# Metro South-West Joint Development Assessment Panel Agenda

Property Location:	Lot 804 Stillwater Drive, Baldivis WA 6171
Application Details:	Construction of a New Public Primary School
	'Rivergum Primary School'
DAP Name:	Metro South-West JDAP
Applicant:	Bateman Architects
Owner:	Minister for Education
LG Reference:	20.2014.239.1
Responsible Authority:	Department of Finance (Building Management
	and Works
Authorising Officer:	Peter Gillies, Assistant Director
	Land Assembly Branch, Department of Finance
	(Building Management and Works)
Department of Planning File No:	DAP/14/00562
Report Date:	20 August 2014
Application Receipt Date:	18 June 2014
Application Process Days:	62 Days
Attachment(s):	1 - Location and Aerial Photograph Plans
	2 - Site Feature Survey
	3 - Development Plans (Site Plan/Floor
	Plans/Elevations)
	4 - Traffic Report
	5 - Response from the City of Rockingham
	6 – Acoustic Report
	7 – Response from Main Roads WA

**Approve** DAP Application reference DAP/14/00562 and accompanying plans for the New Public Primary School in accordance with the 'Rivergum Primary School' drawings prepared by Bateman Architects, being:

## **SITE PLAN**

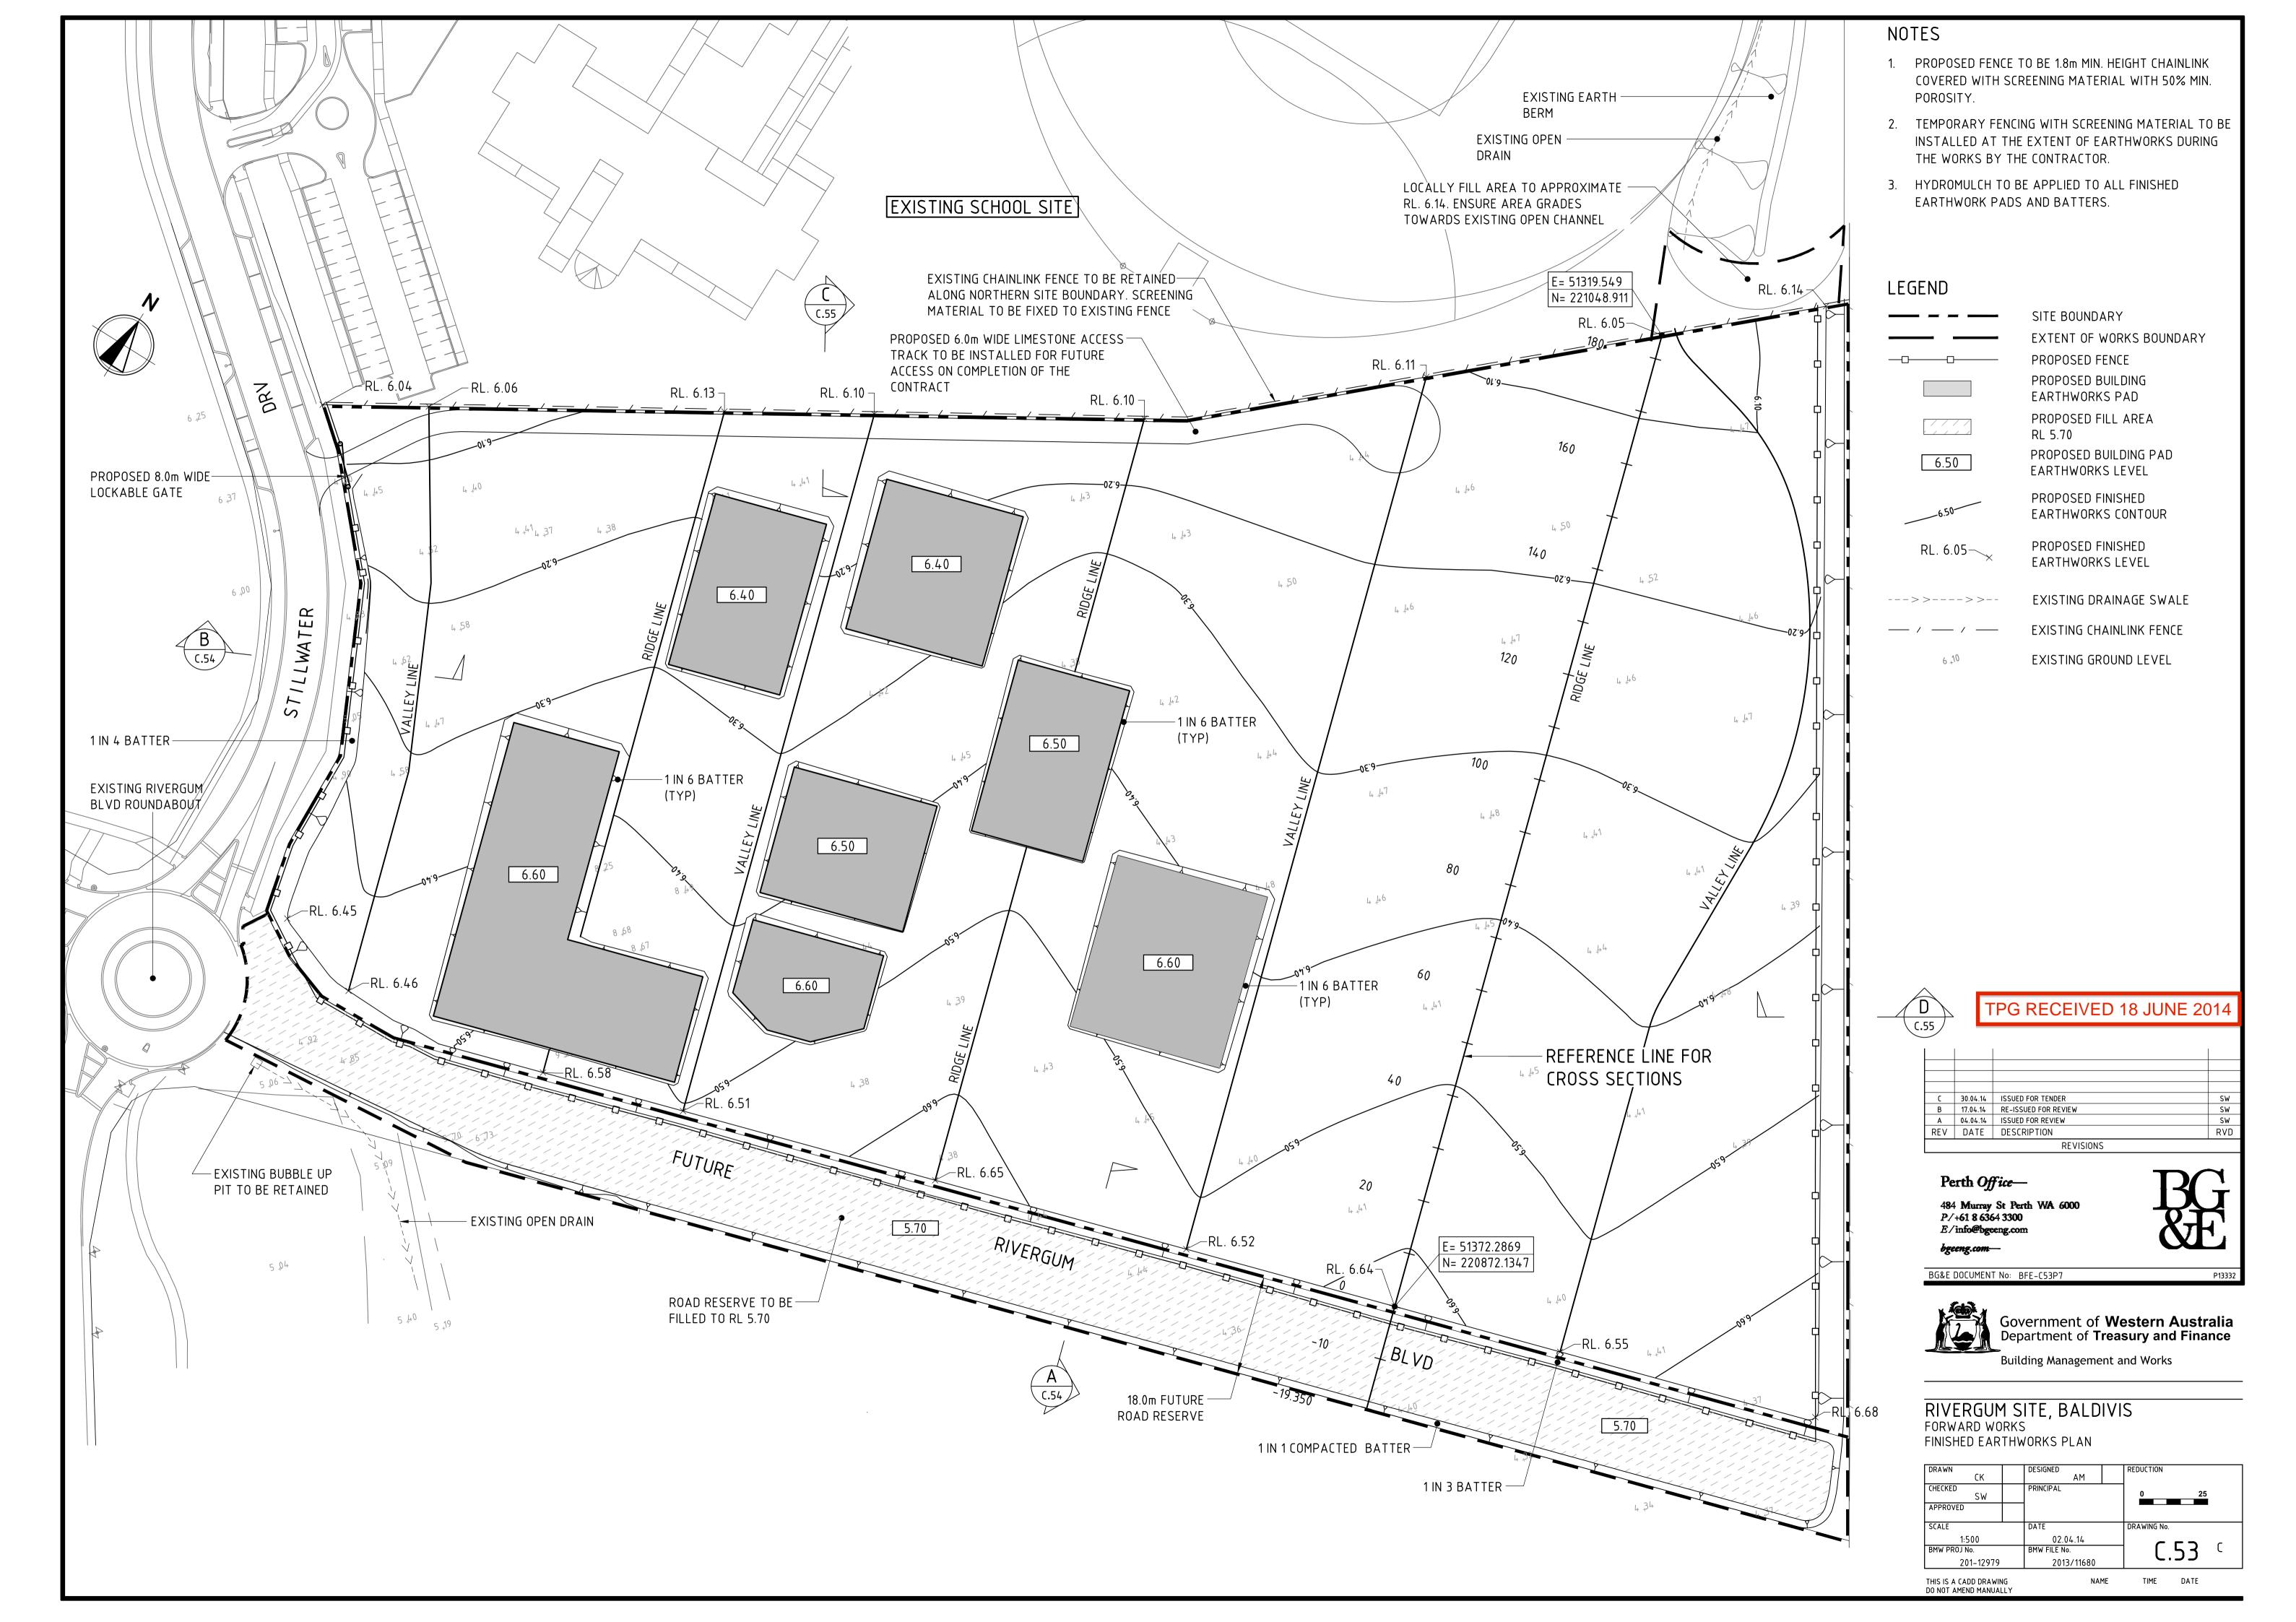
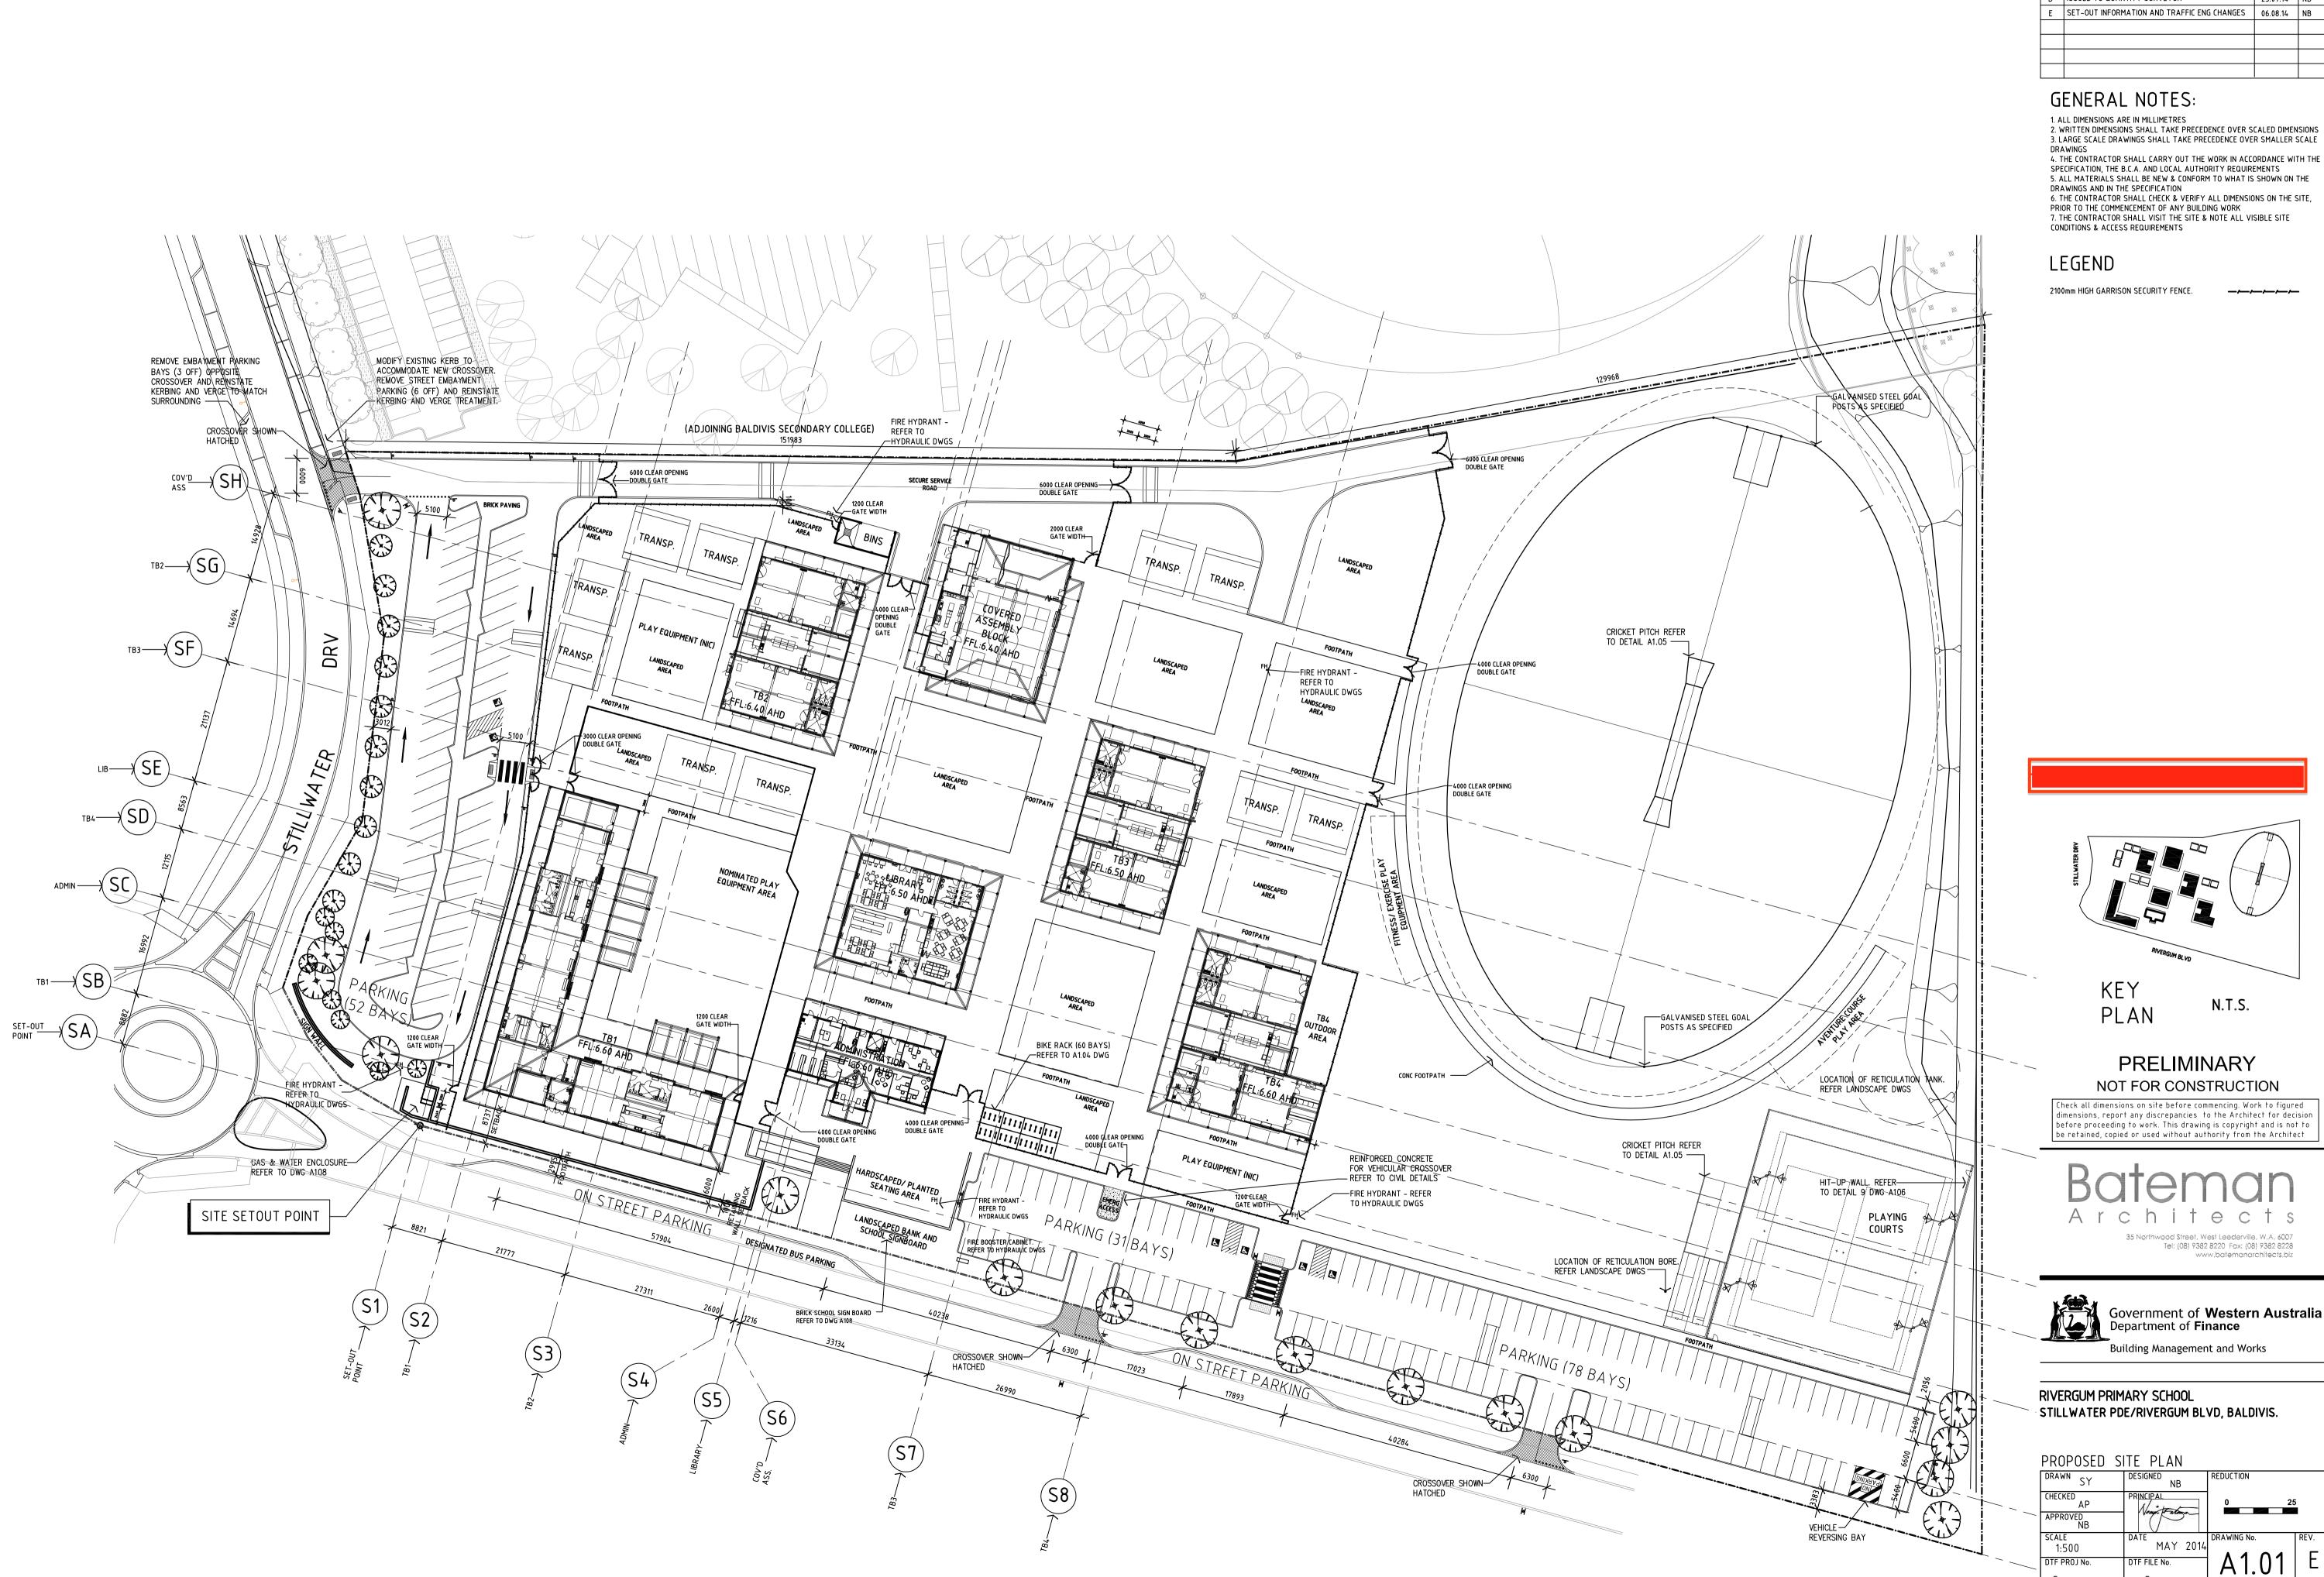
1. This Approval shall be in accordance with the amended development application plans (Drawing No. A1.01 Rev. E), received by the City on 7 August 2014.

It is considered that this is covered by the standard approval wording, which requires that the development be carried out in accordance with the approved plans. It is therefore not necessary to include as a separate condition.
